RE: Amerada Hess Corp
750 Cliff Rd
Woodbridge, Middlesex
EPA ID No. NJD045445483
PI #: 006148

The New Jersey Department of Environmental Protection (Department) has completed a review of the Remedial Investigation Work Plan – AOC 11A Administration Building dated April 6, 2016, and as amended in the March 24, 2017 response to comments, submitted pursuant to the Resource Conservation and Recovery Act (RCRA), and the NJDEP Technical Requirements for Site Remediation at N.J.A.C. 7:26E (Tech Rules).

additional information on the former property owner (Petroleum Solvents Corporation) and a soil sample from the AST Farm (AOC 77). There was no SI sampling conducted at AOC 78 or 79. The AOCs are shown in the portion of Figure 5 (November 2015 SIR), below:

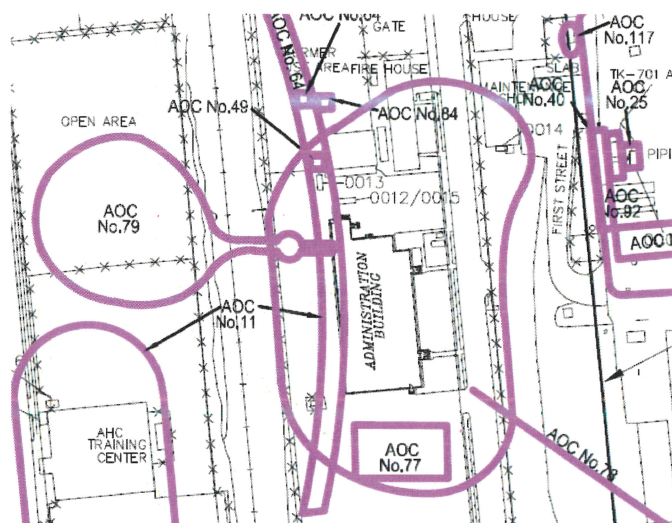
The investigation should include efforts to delineate source area(s) for targeted remedial action design and plume migration and delineation for receptor evaluations. The field effort shall include AOC 77, connection to AOC 78 and the AOC 79 area.

- The proposed locations must be reevaluated with the summary figure that shows MW and TW locations and the other AOC 11A information (Item 4, above). The Department notes that the proposed locations will not advance the remedial design for the AD-2 and the AOC 77 areas, or plume delineation (AD-5D, AD-TW-7, AD-TW-9).

10. The scope of what area(s) comprise Area of Concern 11A is confusing. Based on Hess's description, there seem to be multiple known and potential contaminant sources at or near the Administration Building. The RIWP is entitled AOC-11A: Administration Building. This differs from Page 1 text where Hess states that issues regarding underground storage tanks (USTs), soil and groundwater conditions near the Administration Building have been designated as AOC-11. The Department notes that free product and soil saturated with product was present when the USTs were removed. Hess also says that a plume of chlorinated solvents has been attributed to a Quality Control laboratory within the Administration Building. Then, on Page 3 of the RIWP, Hess mentions a former aboveground storage tank farm (ASTs) immediately south of the Administration Building, and a former culvert southeast of the Administration Building.

The Department is unable to discern whether all of the potential sources and preferential pathways are being addressed in the current RIWP versus other documents, and if so, which documents. The Department is concerned with the approach of splitting up the area into multiple segments without a clear justification to do so.
